## **14.0 ADDITIONAL TECHNICAL INFORMATION**

# SCHAAF & WHEELER HYDROLOGY AND WATER QUALITY RESPONSE TO PUBLIC COMMENTS MEMO

## ENVIRONMENTAL IMPACT ANALYSIS GAVILAN SAN BENITO CAMPUS

### CALIFORNIA REGIONAL WATER QUALITY CONTROL BOARD

**Exhibit 1: Existing Drainage Basins**

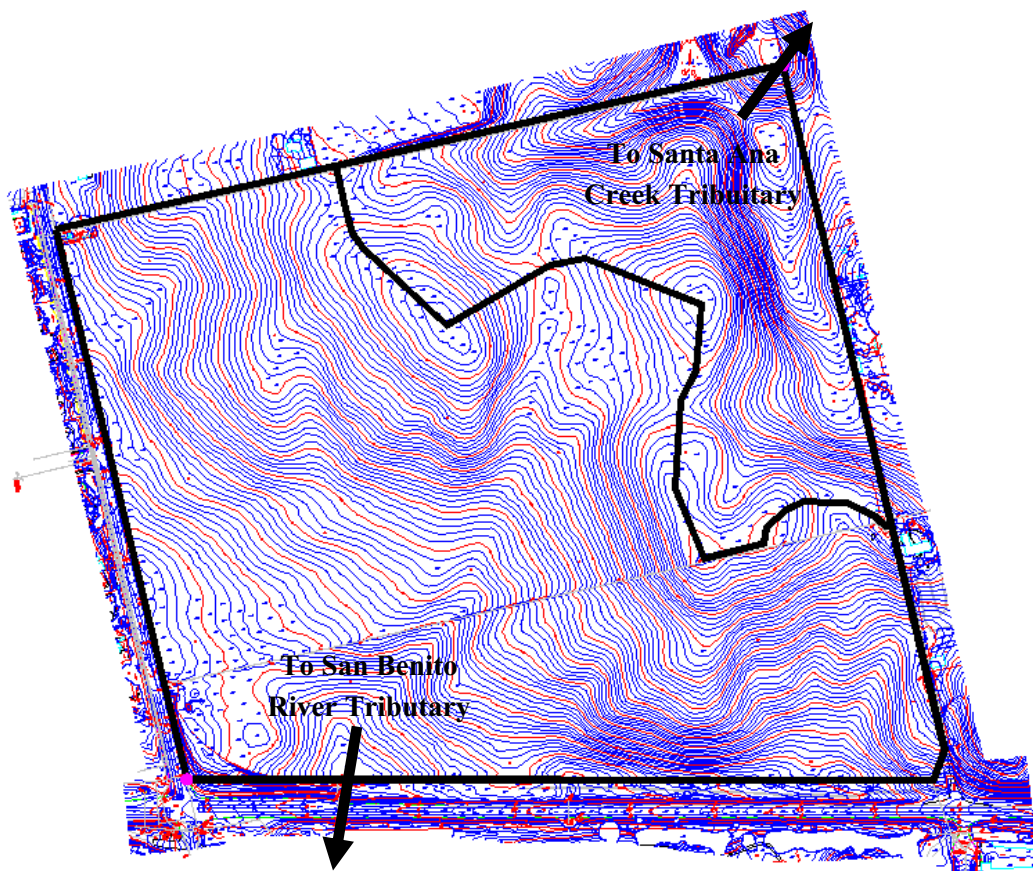
**Comment – Post-Development Runoff Conditions**

***Existing vs. Proposed Drainage Conditions***

The existing site naturally splits drainage between two catchments as shown in Exhibit 1. Approximately 110 acres of the 138-acre site now drain to a tributary of San Benito River that runs along Airline Highway. The remaining 28 acres drain to an unnamed tributary of Santa Ana Creek.

Due to property ownership issues, it is not possible to provide a safe outfall for newly generated storm water runoff to the Santa Ana Creek tributary; and as subsequently discussed, on-site retention is not considered to be feasible. Therefore grading and drainage plans for the proposed project call for all of the developed site's drainage to discharge into the San Benito River Tributary.

**Exhibit 3: Flow-Duration Curves for the San Benito River Tributary**

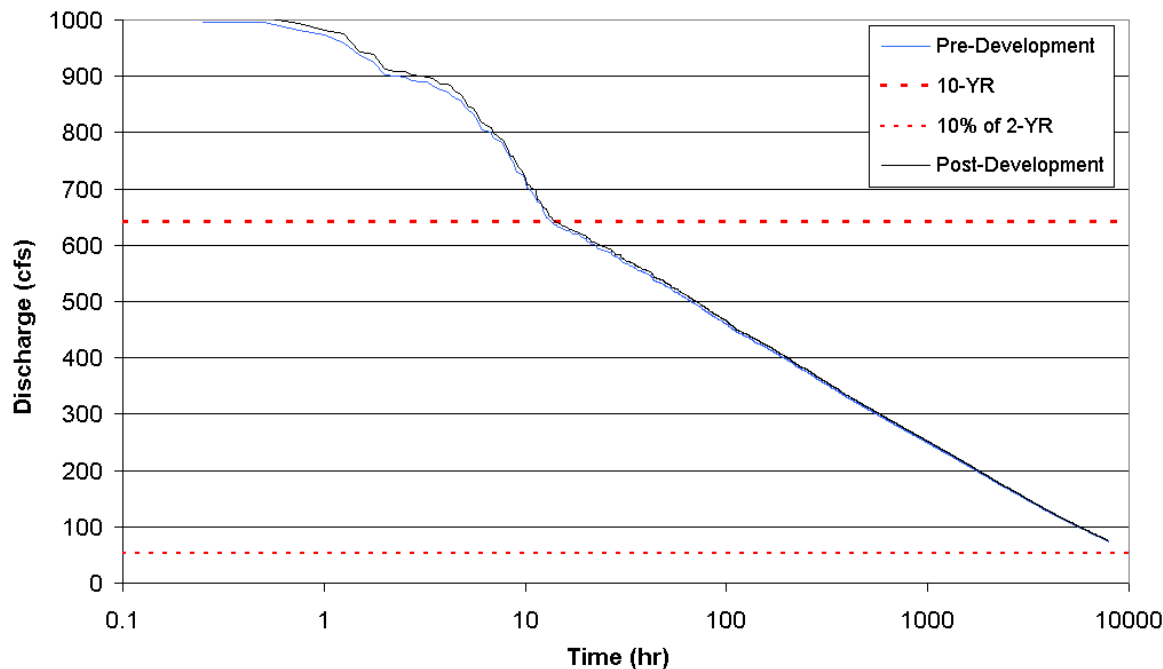
#### **Comment – Small Storm Events**

Research has shown that smaller events (particularly the one- and two-year return storms) have the greatest impact on stream channel formation and stability due to their frequency. These small storm events also carry the majority of the pollutants in urban stormwater runoff. In order to achieve the Water Board's desired conditions of healthy watersheds, the project should maintain watercourse geomorphic regimes within natural ranges. Therefore we recommend the project area's post-development hydrograph match the pre-development hydrograph for a range of storm events with return periods from one year to ten years. This can be achieved by reducing impervious area, disconnecting impervious area, maximizing retention and recharge and retaining the pre-development topography and drainage patterns as much as possible.

We used the Bay Area Hydrologic Model (BAHM) to address this question of hydromodification; that is, smaller runoff events that could impact stream channel formation and stability. The appropriate location for this examination is at the project site's proposed outfall to the San Benito Creek tributary (as illustrated in Exhibit 2). Exhibit 3 compares flow-duration hydromodification curves at the San Benito Creek tributary, showing a full range of flow frequencies based on continuous rainfall-runoff simulation.

As to the potential for hydromodification and increased downstream erosion, differences in the pre-developed and post-developed flow-duration curves plotted in Exhibit 3 are barely discernable graphically. In neighboring Santa Clara County, hydrologists are interested in the portion of the curves for discharges between ten percent of the two-year event and the ten-year event. For conventional development the flow-duration curve is about one percent higher than the pre-developed condition; for low impact development the curve is two percent higher; and for LID with detention the curve is about three percent higher. Hydromodification is not considered to be a significant impact, but it may be noted that LID techniques do not necessarily improve the situation numerically.
